Ashton Village Center

SECTOR PLAN

Ashton Village Center Sector Plan

Work Session #2

Architecture & Building Materials

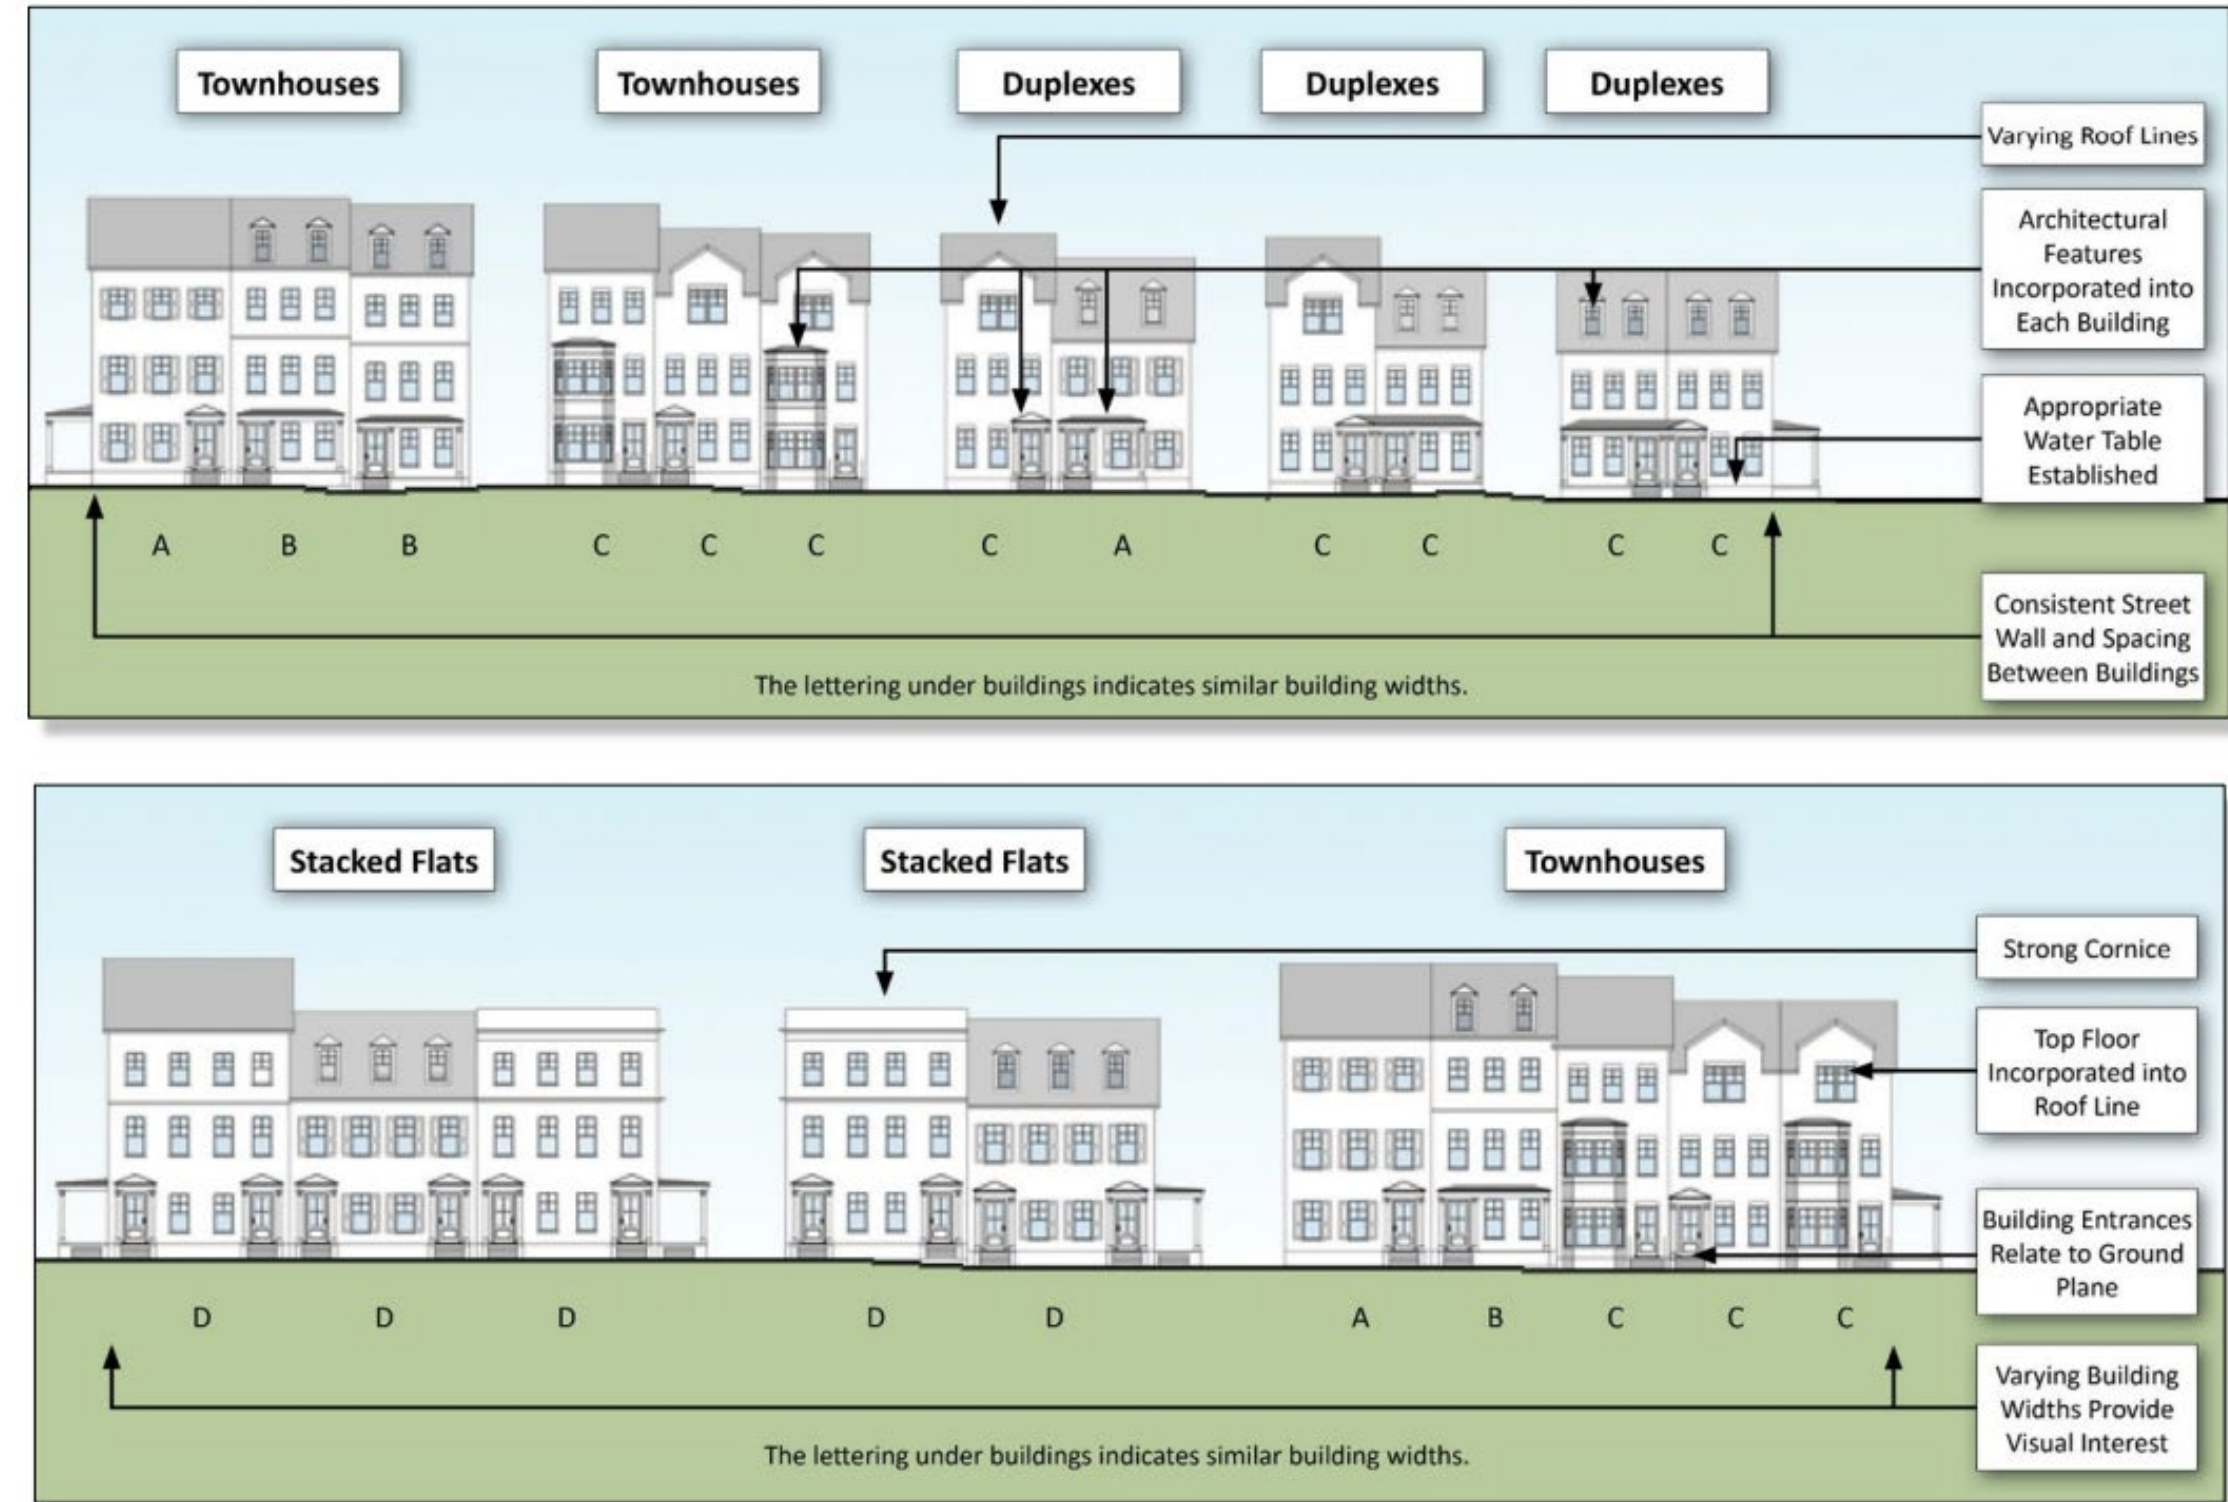
- General support for recommendations
- Property owner: Add cement fiber siding imitating wood cladding

- Revise the Plan language to include cement fiber siding imitating wood cladding

Precedent Images

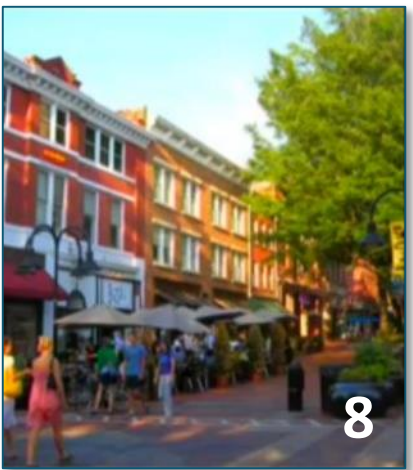
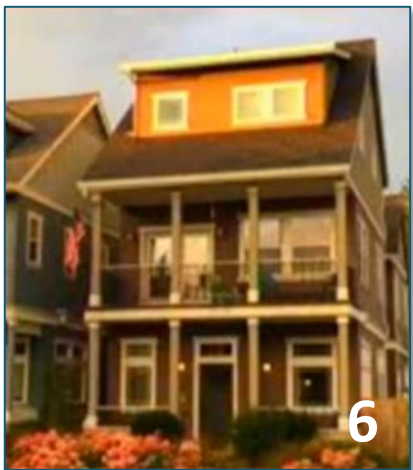
- Property owner: Some of the precedent images in the Plan would not be allowed

- Retain the images in the Plan to show examples of the guidelines consistent with a rural village

Implementation Advisory Committee

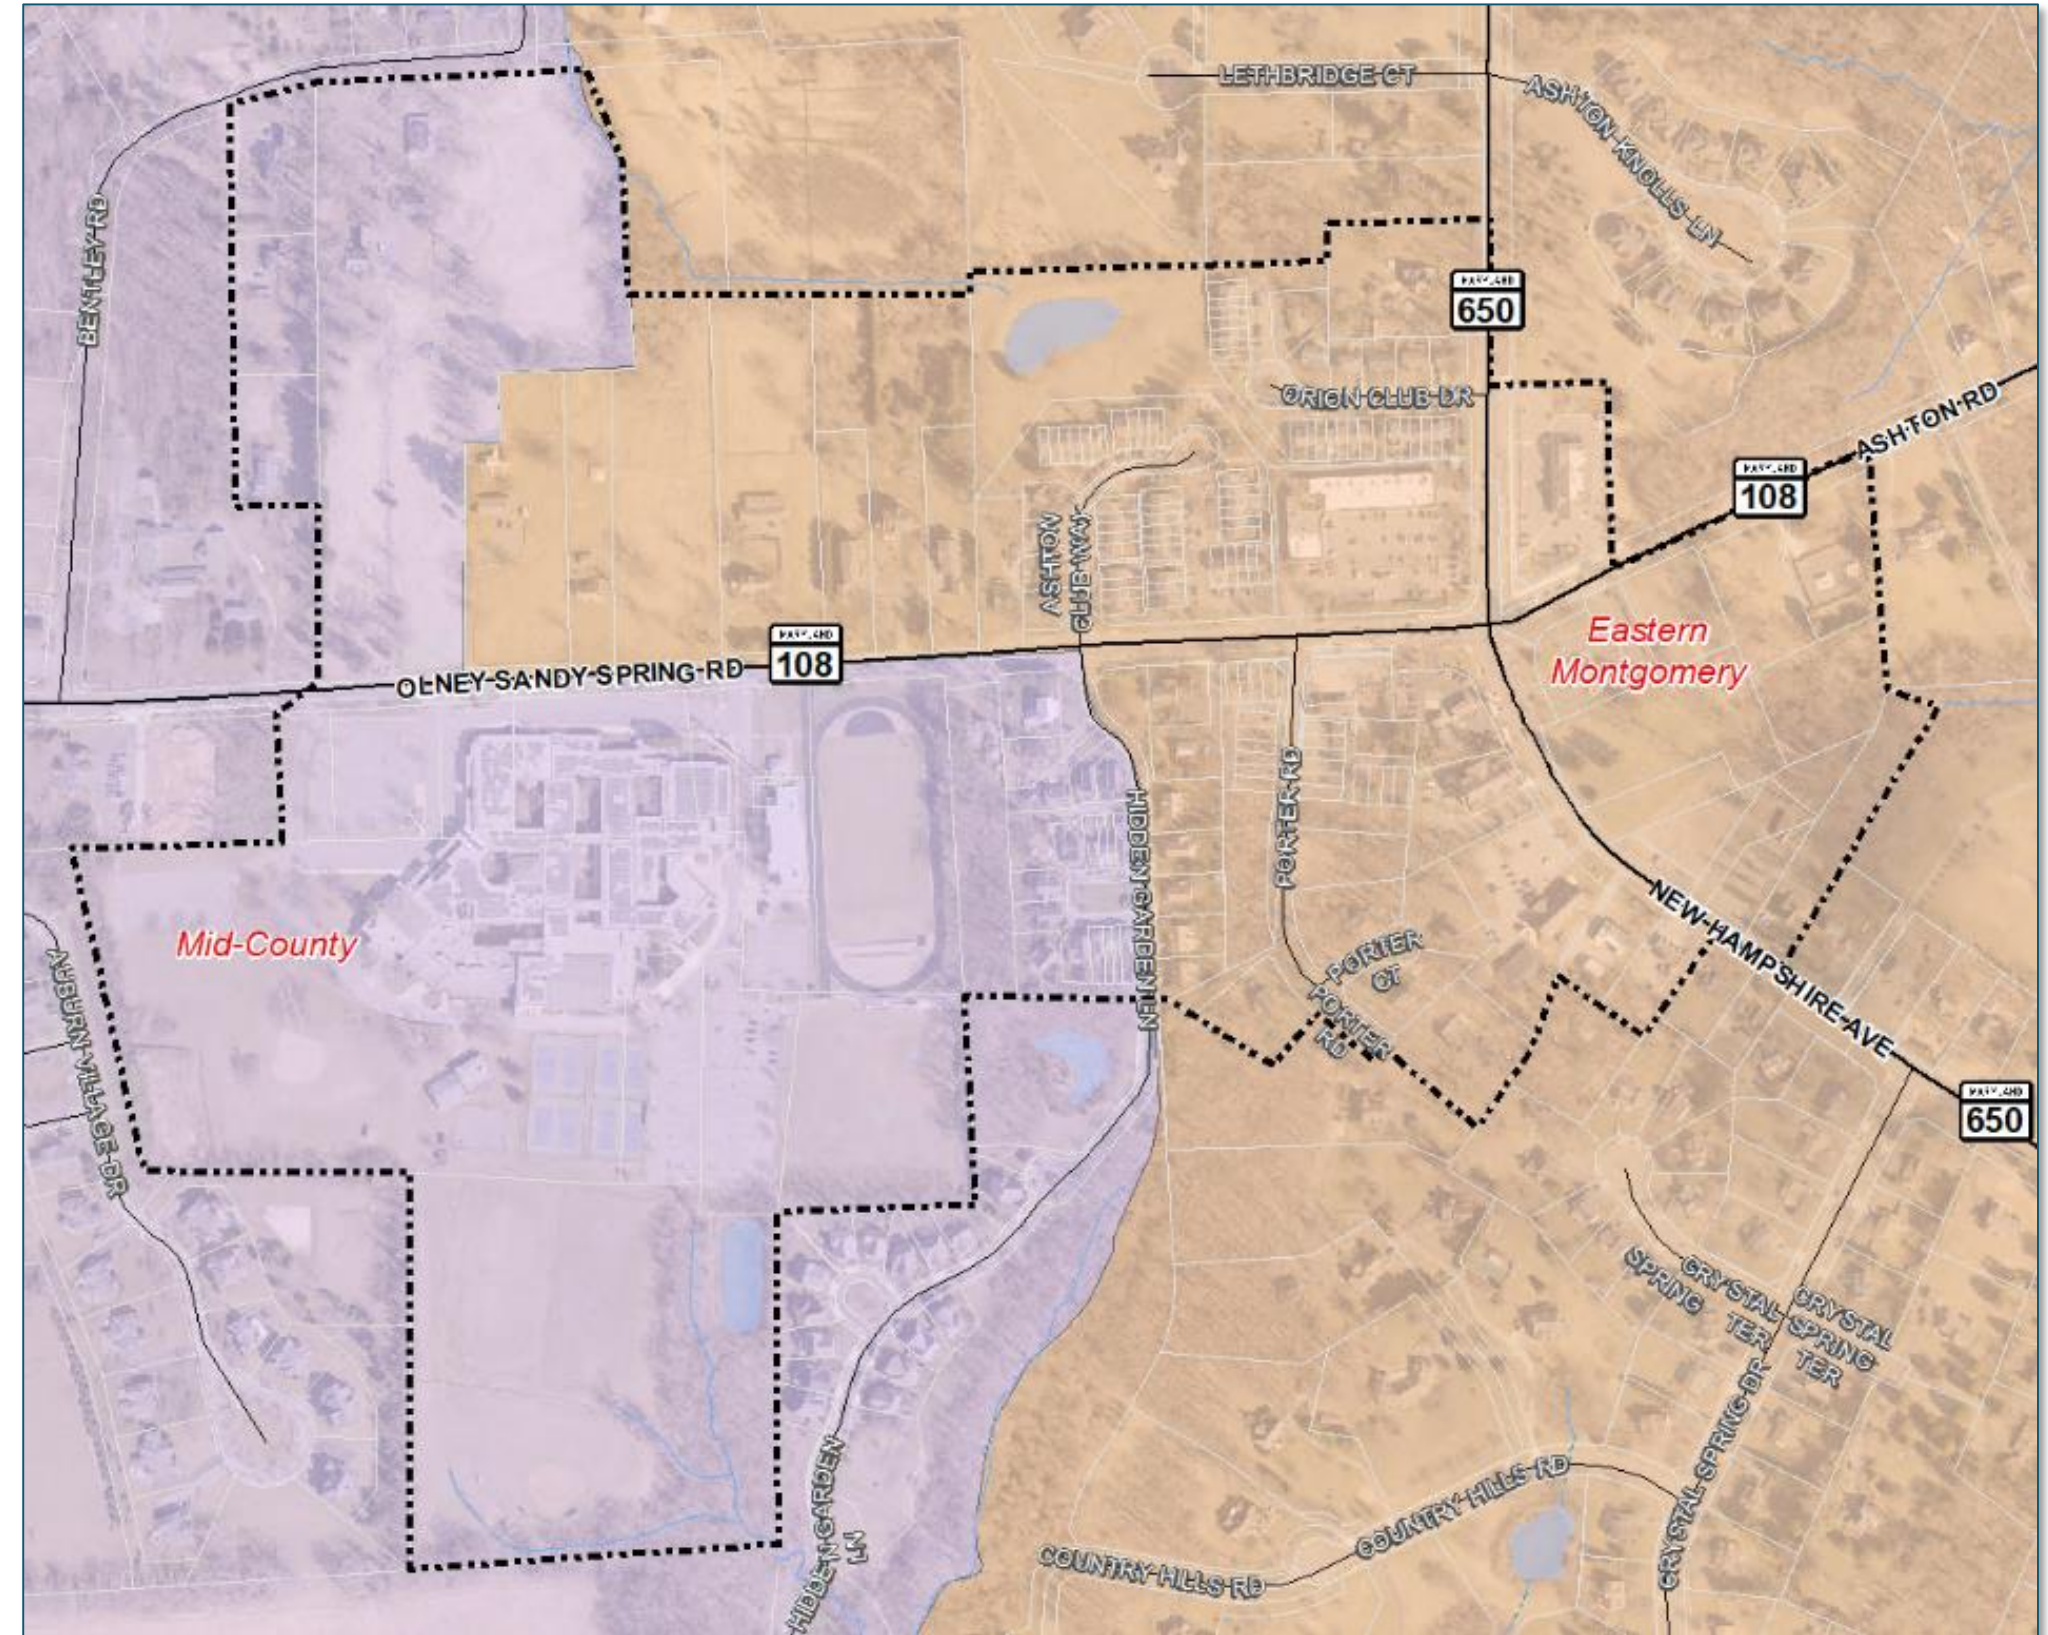
- Provides a formal channel of communication
- Provides oversight of development activity and capital improvement projects to ensure the Plan's vision is maintained
- Requested veto power over plans that threaten rural character
- Property owner:
 - Requested we eliminate the committee:
 - Only one main developer
 - The site plan process already provides opportunities for community input
 - Would only increase delays and costs
 - If implemented, provided several suggestions for make-up and functioning of the IAC

- Retain the Plan's recommendation
 - Details to be determined after the Plan is adopted but would likely include:
 - Any development project would go to the IAC
 - IAC would comment on all development review aspects
 - IAC would address non-development concerns, such as capital improvement projects
 - Should not cause unreasonable costs or delays
 - Applies to the entire Plan area
 - Do not support giving the IAC veto power

Southwest Quadrant Zoning Revisited

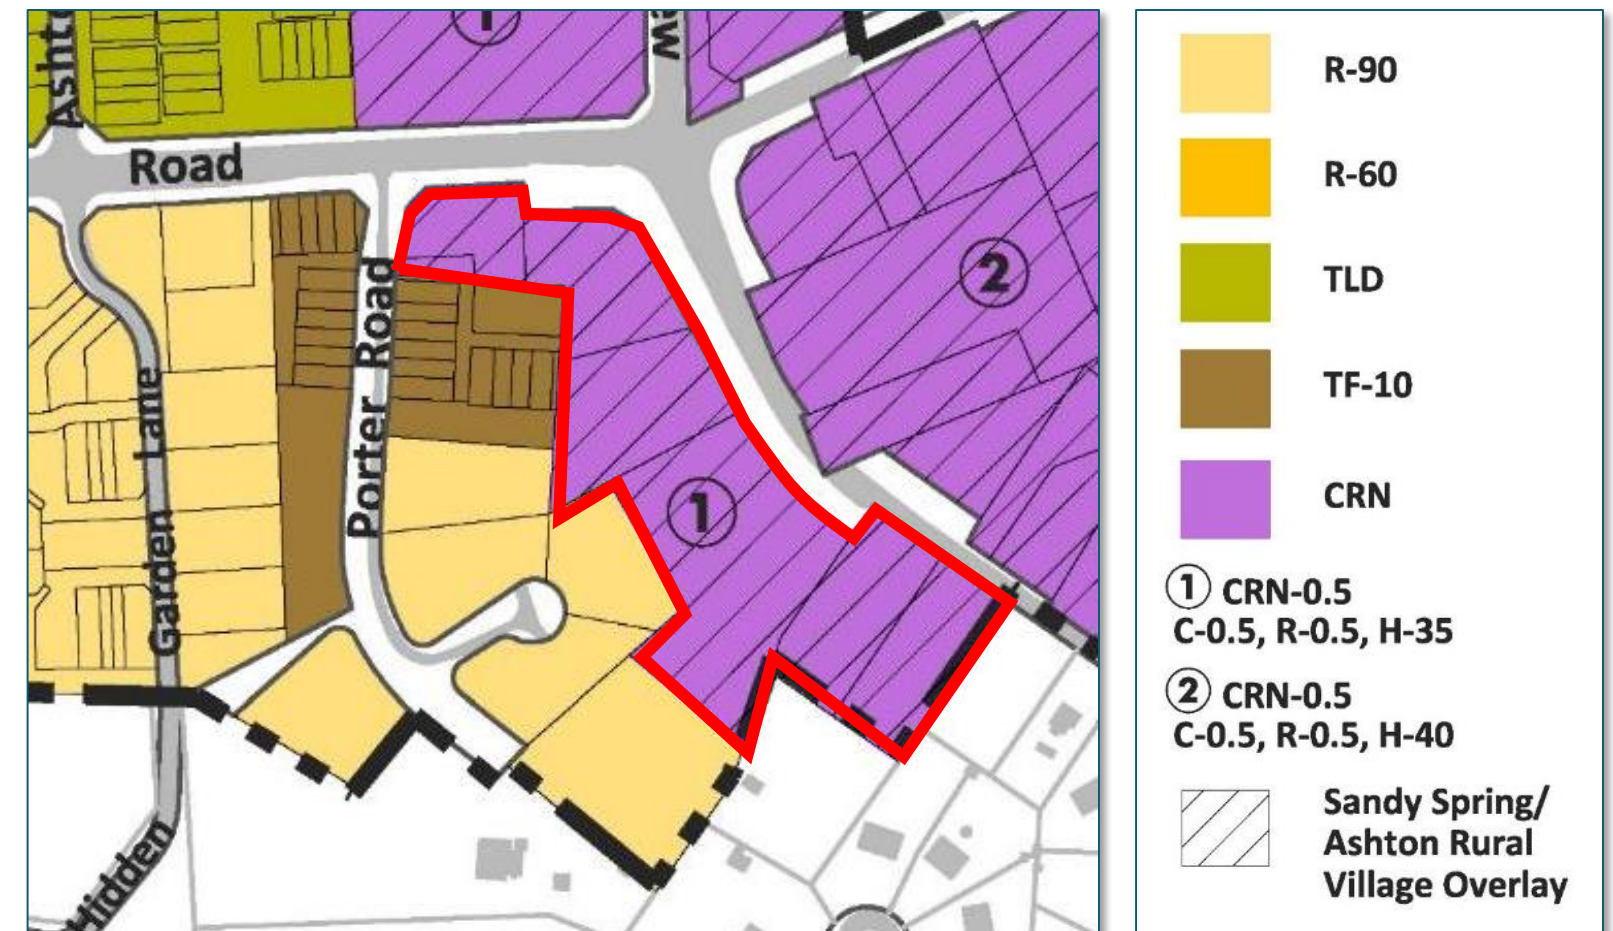
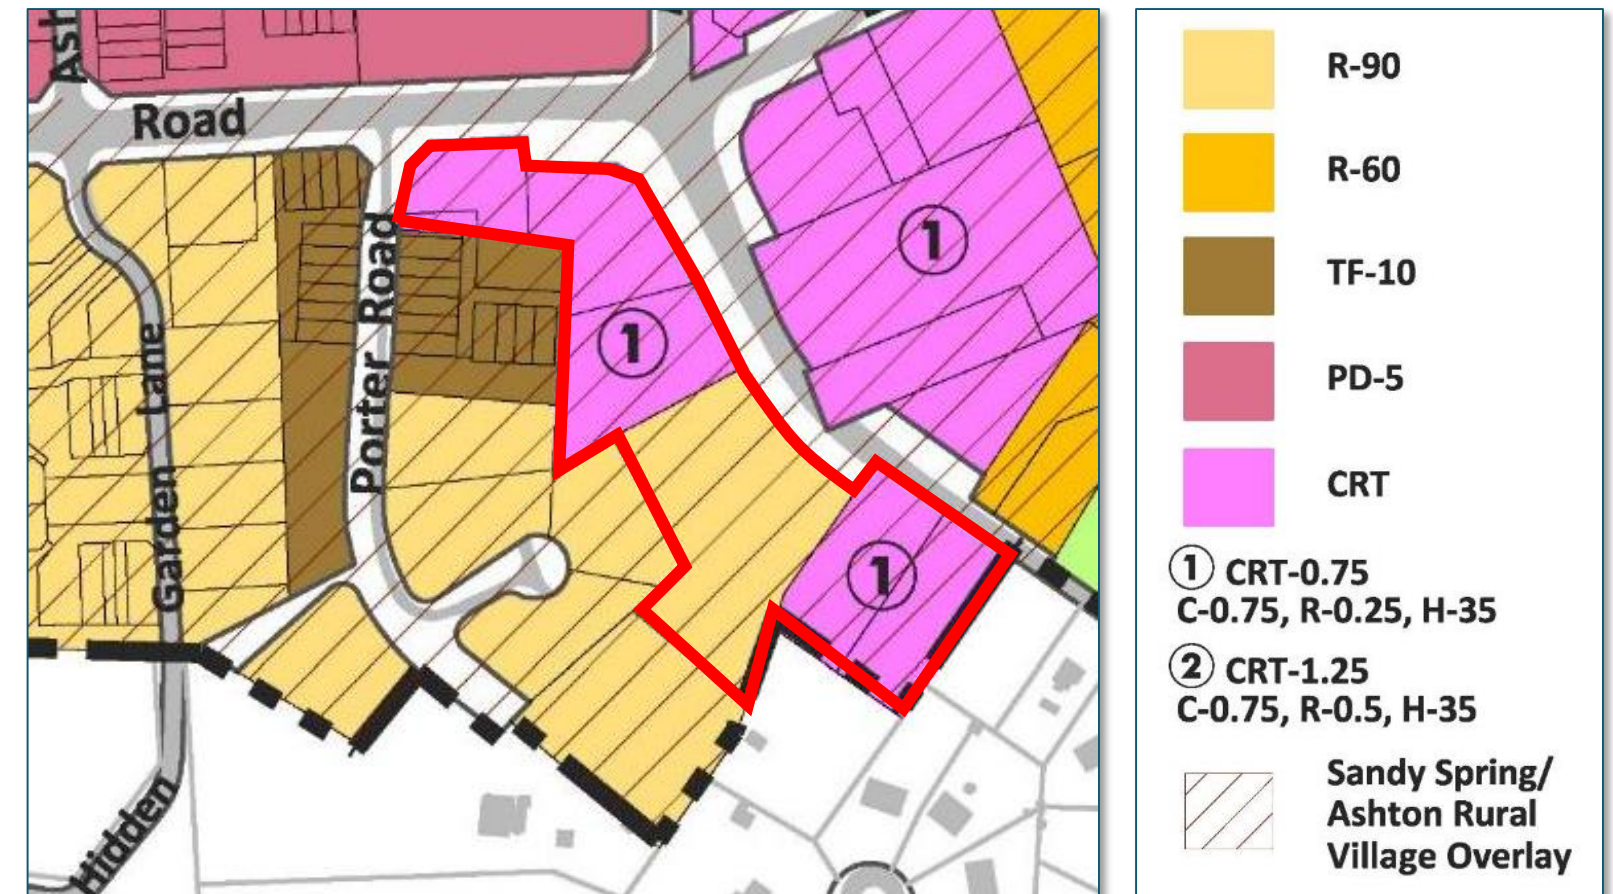
- CRN-0.75 C-0.5 R-0.5 H-35
(written testimony) or
- CRN-0.75 C-0.75 R-0.25 H-35
(public hearing testimony)

- Retain the Plan's recommendation (CRN-0.5 C-0.5 R-0.5 H-35)
 - Current approved densities: overall 0.34 FAR (C-0.23 R-0.11)
- Density of 0.75 FAR typically requires structured off-street parking or additional building heights which is not consistent with a rural village
